## **PERCH BEND SUBDIVISION**

APPLICATION NUMBER 18 DATE August 18, 2005  
APPLICANT Perch Bend Subdivision  
REQUEST Subdivision

# PERCH BEND SUBDIVISION

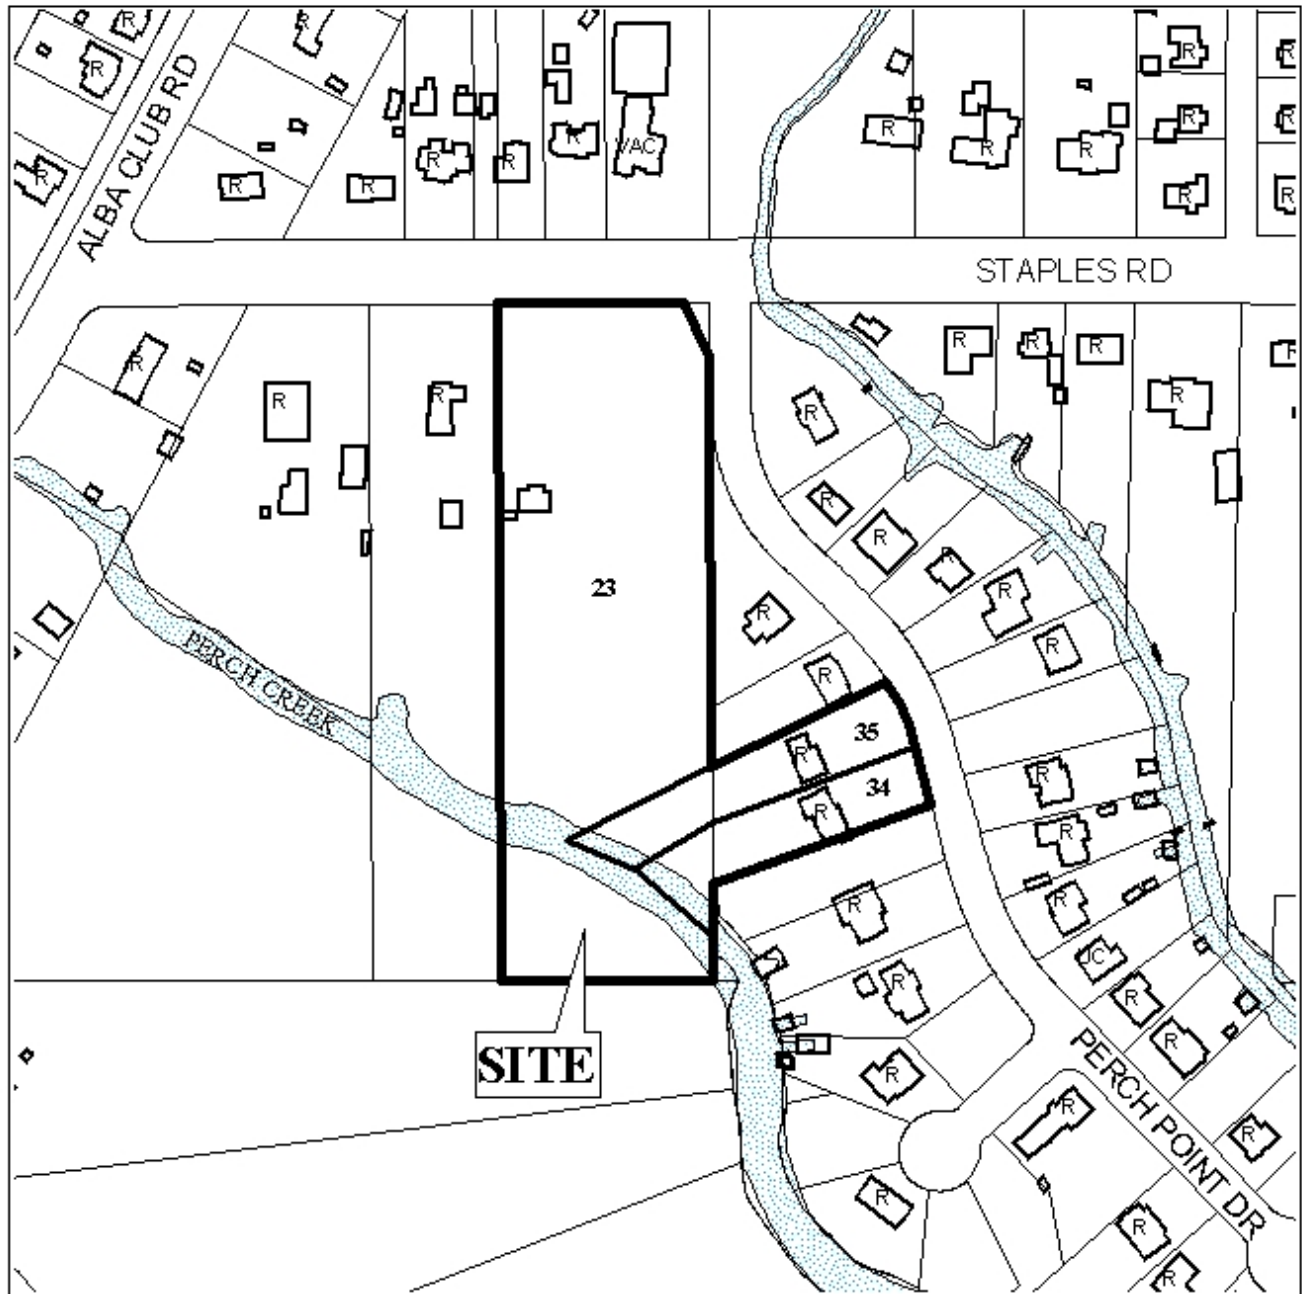
Engineering Comments: Flood zones are not delineated on plat as required. In addition, a minimum finished floor elevation must be specified on the plat (on the specific lot) for any lot that is affected by the x-shaded and AE flood zone. Must comply with all stormwater and flood control ordinances. Any work performed in the right-of-way will require a right-of-way permit.

The 25-foot minimum building setback lines are not shown but would be required on the final plat.

With a waiver of Section V.D.3. (width to depth ratio), the plat will meet the minimum requirements of the Subdivision Regulations and is recommended for Tentative Approval subject to the following conditions: 1) Compliance with City Engineering Comments: (Flood delineated on plat as required. In addition, a minimum finished floor elevation must be specified on the plat (on the specific lot) for any lot that is affected by the x-shaded and AE flood zone. Must comply with all stormwater and flood control ordinances. Any work performed in the right-of-way will require a right-of-way permit; 2) the approval of all applicable federal, state and local agencies prior to the issuance of any permits; and 3) the placement of the 25-foot minimum setback lines on the final plat.
